Arizona Department of Transportation

MEMORANDUM

Subject: C-Standards Update

Construction Standard Drawings Revisions – April 2006

APPROVED FOR DESIGN <i>May Vipawina</i>	STATE OF ARIZONA DEPARTMENT OF TRANSPORTATION ROADWAY STANDARD DRAWINGS	REV. 4/06
APPROVED FOR DISTRIBUTION <i>John [Signature]</i>	CONCRETE HALF-BARRIER TRANSITION TYPE 'F' TANGENT DEPARTURE TYPE 1	DRAWING NO. C-10.75 Sheet 1 of 2

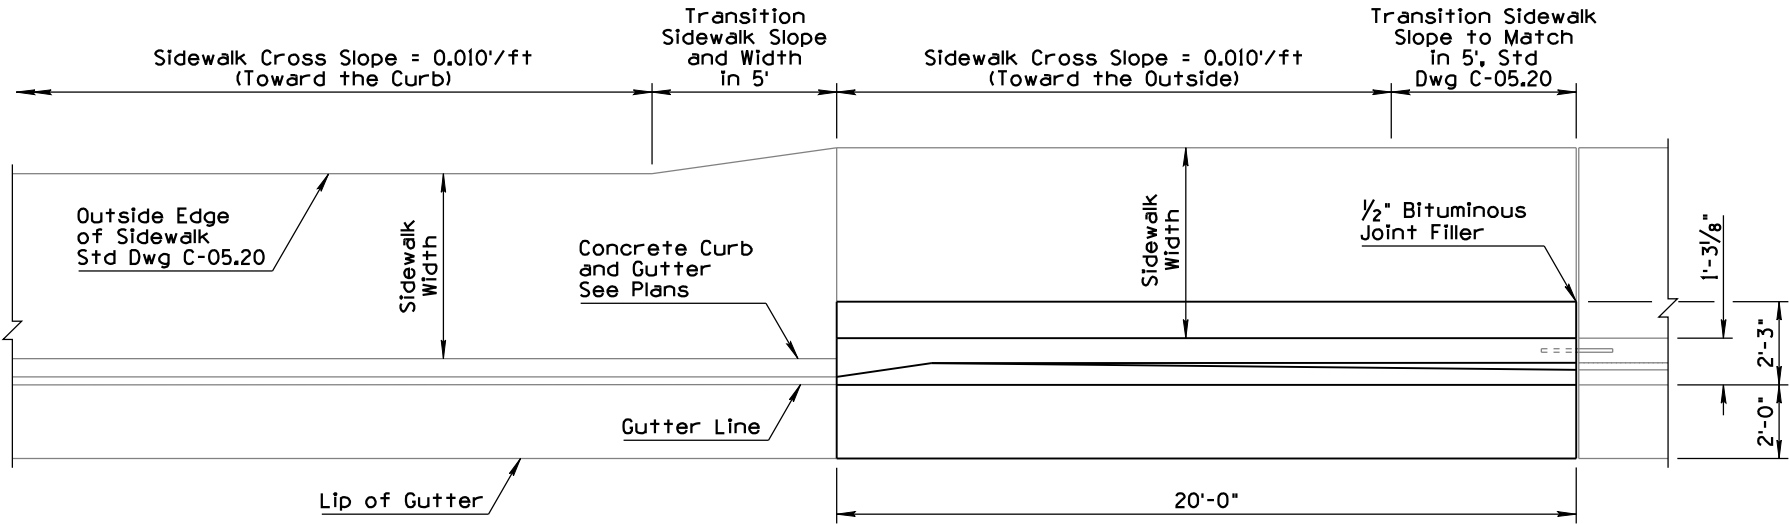
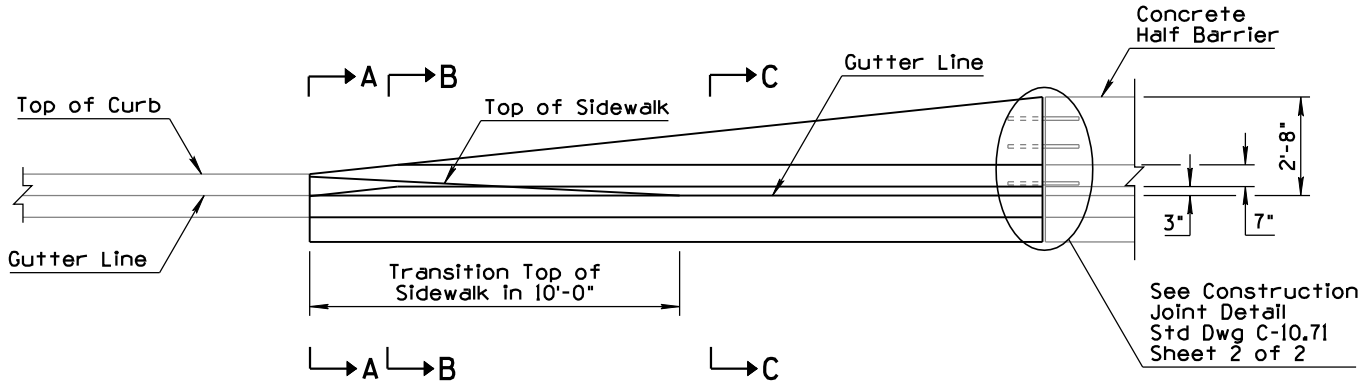
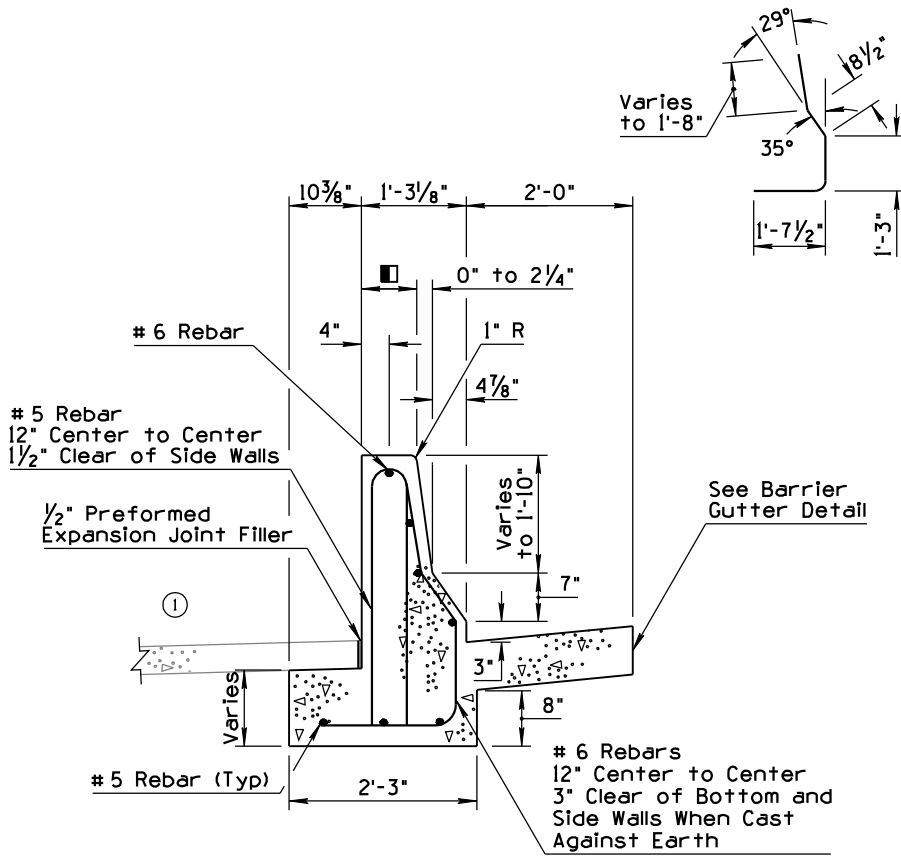
C-10.75, Sheet 1 of 2	Changed "PLAN VIEW" to "PLAN". Removed slope designation from sidewalk in SECTION views. Revised curb-height designation in SECTION A-A from "H" to "h".
C-10.75, Sheet 2 of 2	Changed "PLAN VIEW" to "PLAN". Removed dimensions at right side of PLAN view. Revised text orientation.
C-10.76	Changed "PLAN VIEW" to "PLAN". Revised SECTION view graphics to depict Type 'F' barrier.
C-10.77	Modified PLAN view to correct style and proportion of concrete half barrier and transitions. Modified references to other Std Dwgs.
C-11.10 Sheets 1 through 4 of 4	Re-issued Standard Drawing.
C-15.20, Sheet 1 of 3	Revised sheet number references.
C-15.91 & C-15.92, Sheet 2 of 2	Modified welding notations for ANSI conformance.
C-18.10, Sheet 2 of 3	Modified SECTION views to improve clarity.

NO	DESCRIPTION OF REVISIONS	MADE BY	DATE
1	REVISED SECTION VIEW GRAPHICS	RLF	4/06
2	REVISED 'H' HEIGHT DESIGNATION TO 'h'	RLF	4/06
3			
4

APPROVED FOR DESIGN <i>May Vipawina</i>	STATE OF ARIZONA DEPARTMENT OF TRANSPORTATION ROADWAY STANDARD DRAWINGS	REV. 4/06
APPROVED FOR DISTRIBUTION <i>John Smith</i>	CONCRETE HALF-BARRIER TRANSITION TYPE 'F' TANGENT DEPARTURE TYPE 2	DRAWING NO. C-10.75 Sheet 2 of 2

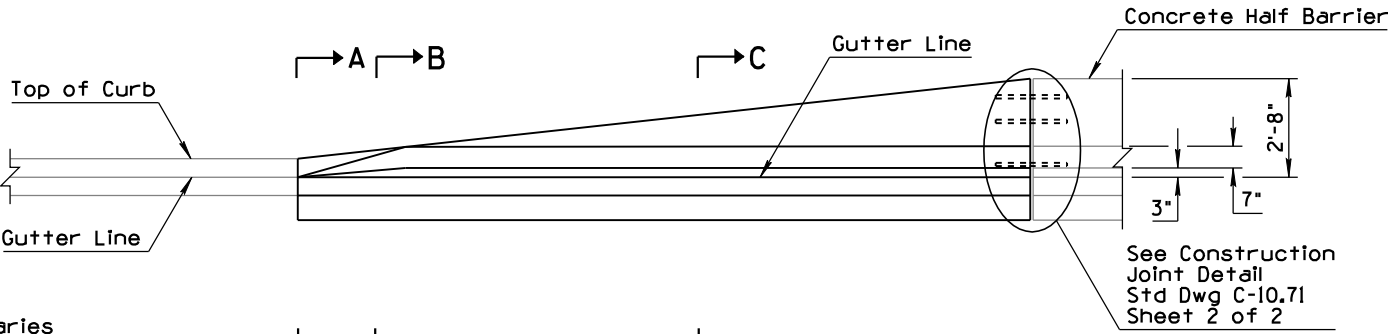
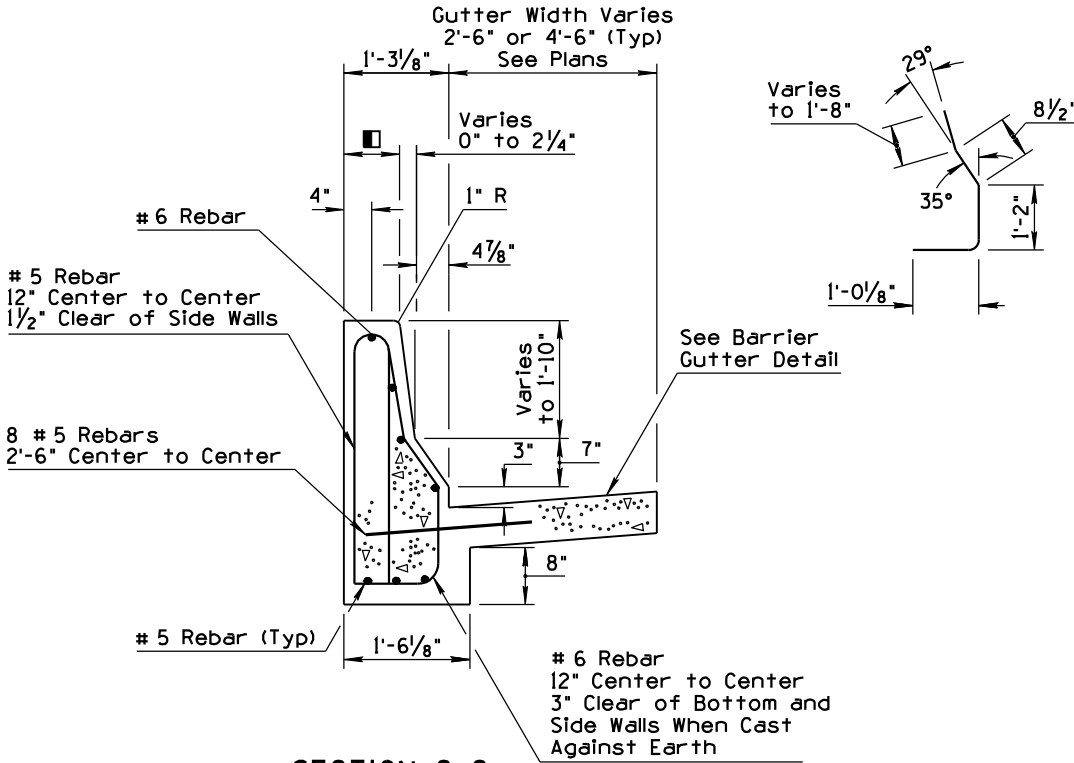
NO	DESCRIPTION OF REVISIONS	MADE BY	DATE
1	REMOVED DIMENSIONS	RLF	4/06
2			
3			
4

APPROVED FOR DESIGN <i>May Vipawina</i>	STATE OF ARIZONA DEPARTMENT OF TRANSPORTATION ROADWAY STANDARD DRAWINGS	REV. 4/06
APPROVED FOR DISTRIBUTION <i>John [Signature]</i>	CONCRETE HALF-BARRIER TRANSITION TYPE 'F' AT RADIUS 32" TO 0"	DRAWING NO. ① C-10.76

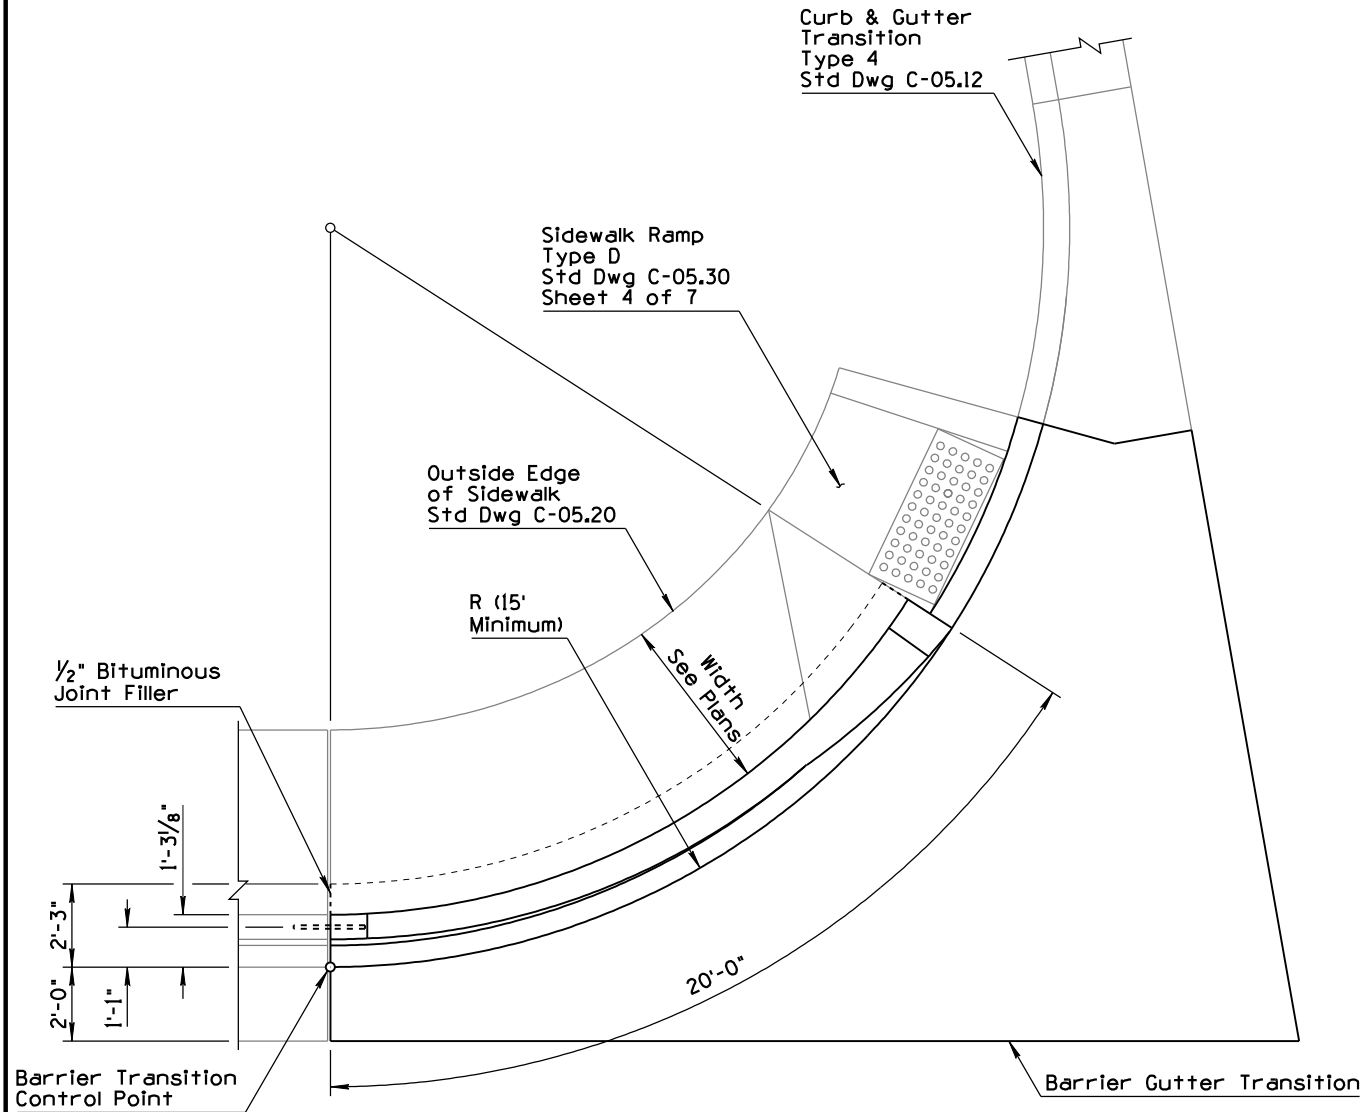
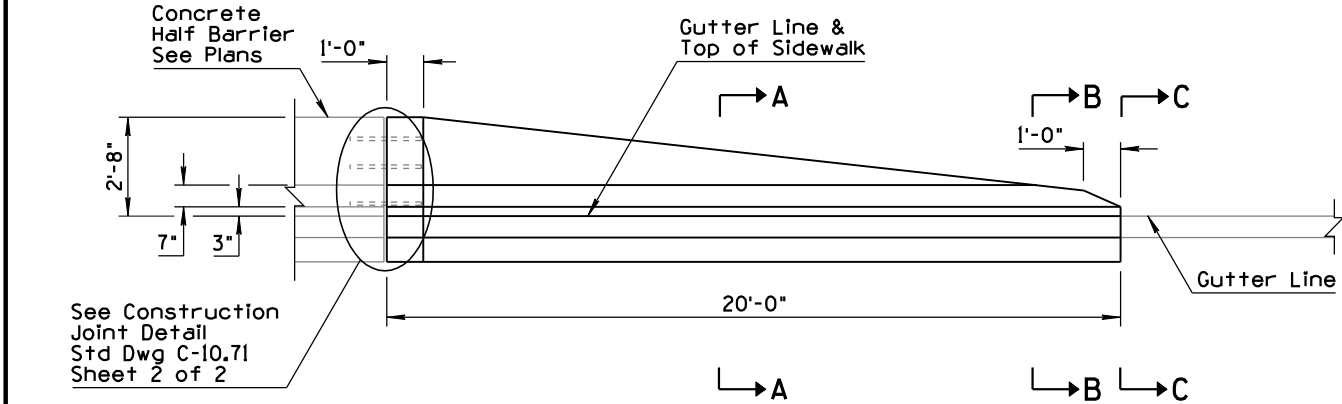
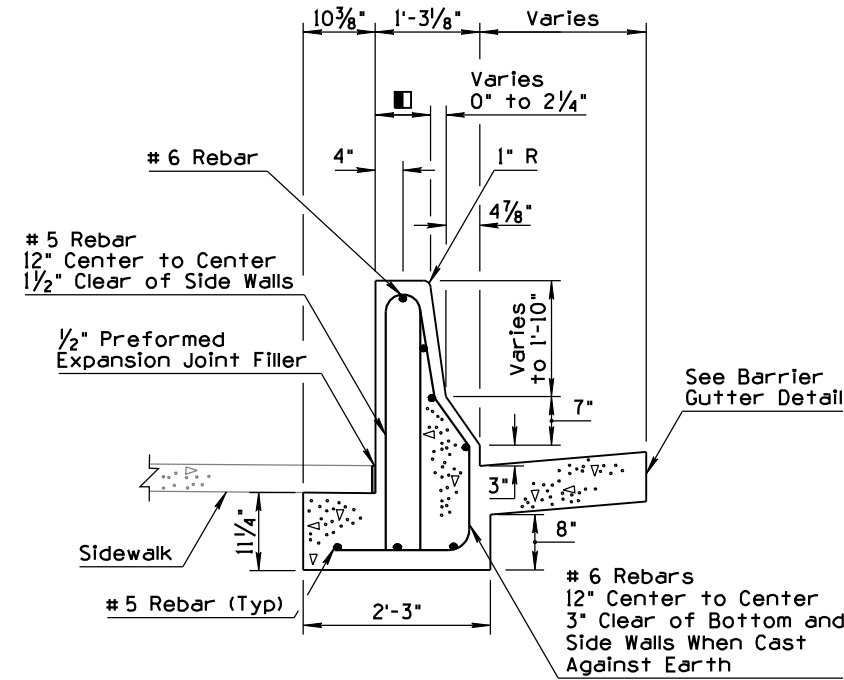
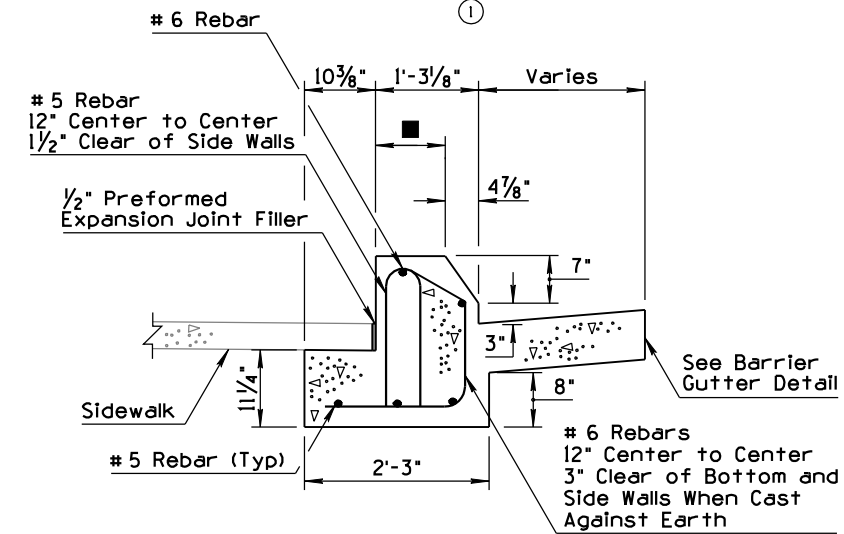
NO	DESCRIPTION OF REVISIONS	MADE BY	DATE
1	REVISED SECTION VIEW GRAPHICS TO SHOW TYPE 'F' BARRIER	RLF	4/06
2			
3			
4

APPROVED FOR DESIGN <i>May Vipawina</i>	STATE OF ARIZONA DEPARTMENT OF TRANSPORTATION ROADWAY STANDARD DRAWINGS	REV. 4/06
APPROVED FOR DISTRIBUTION <i>John Smith</i>	MANHOLE BASE DETAILS NORMAL INSTALLATION	DRAWING NO. ① C-18.10 Sheet 2 of 3

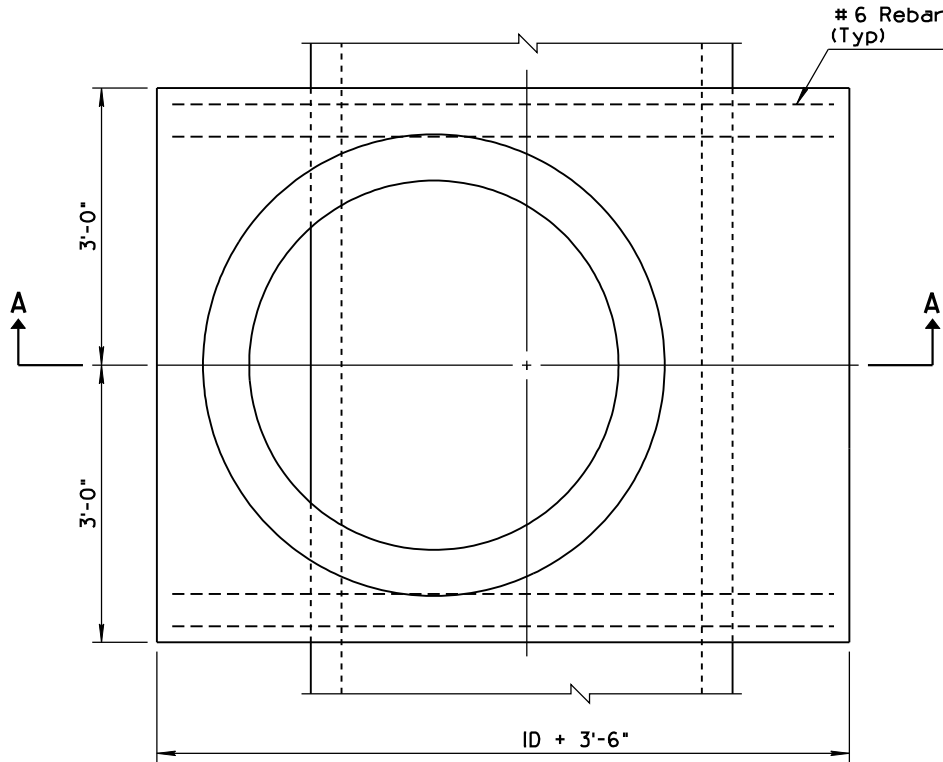
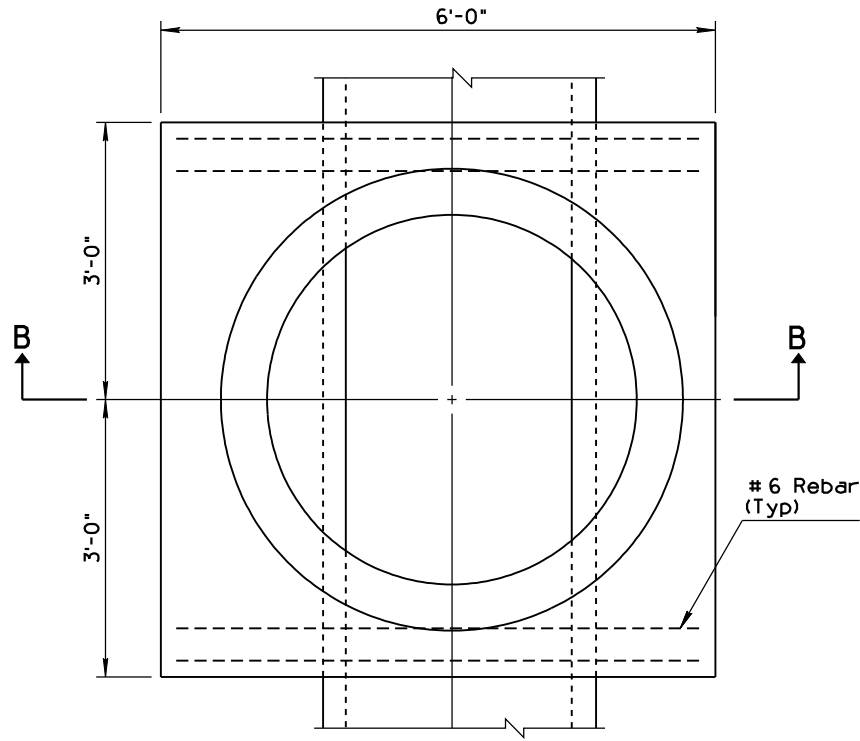
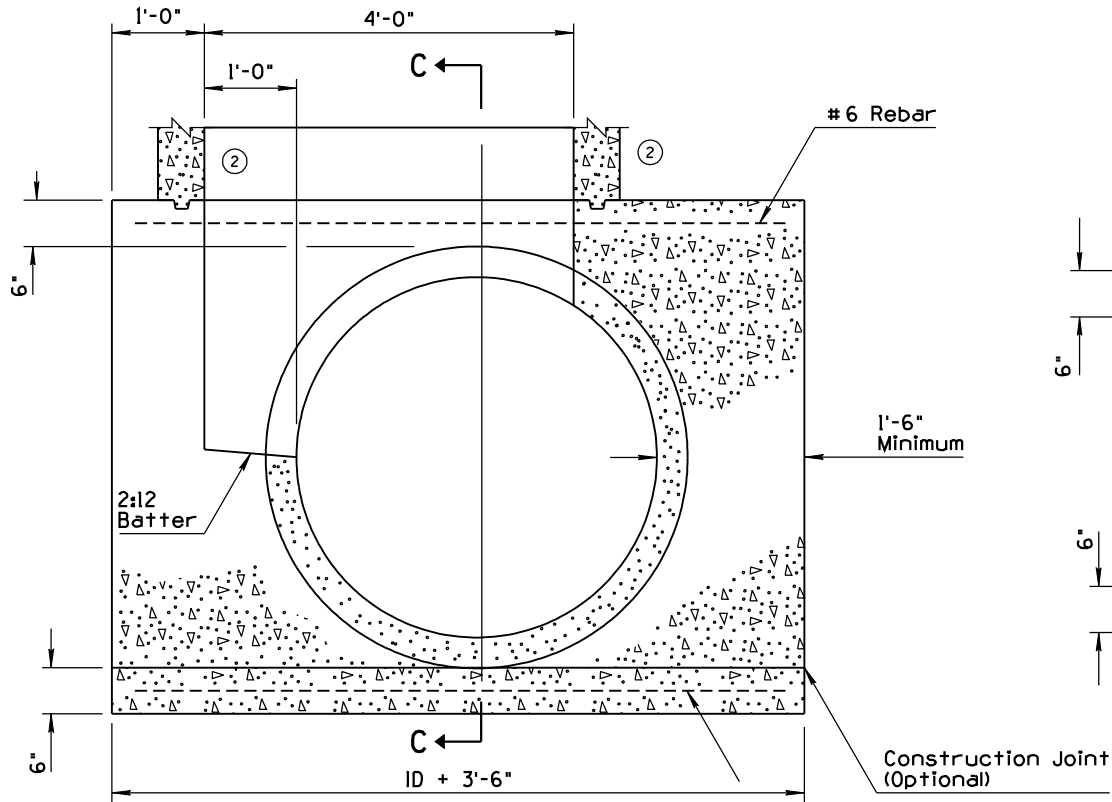
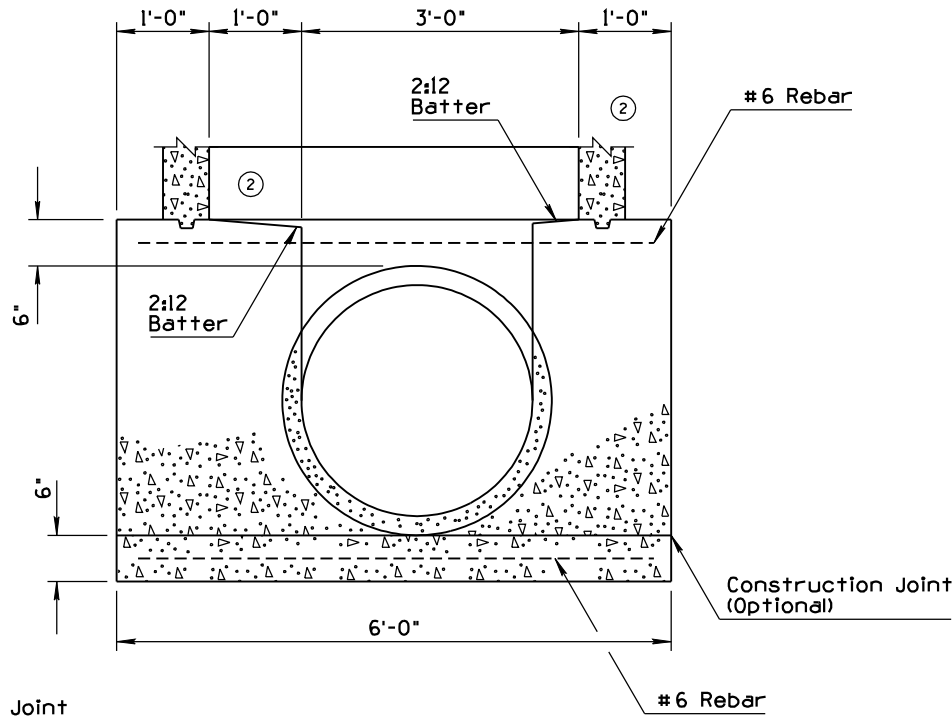
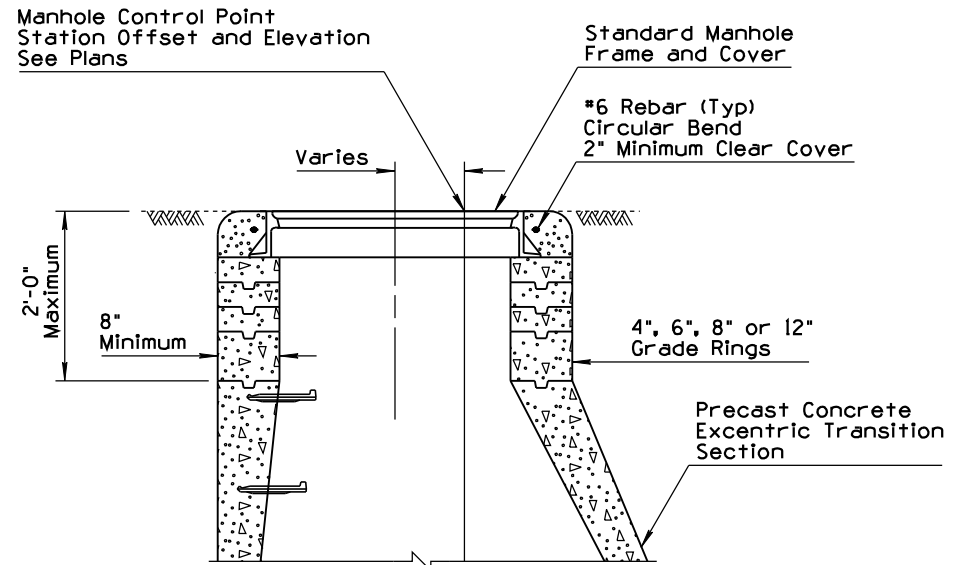
NO	DESCRIPTION OF REVISIONS	MADE BY	DATE
1	RENAMED STD DWG TO C-18.10, SHEET 2 OF 3	RLF	9/04
2	REVISED SECTION A-A THROUGH C-C GRAPHICS	RLF	4/06
3			
4
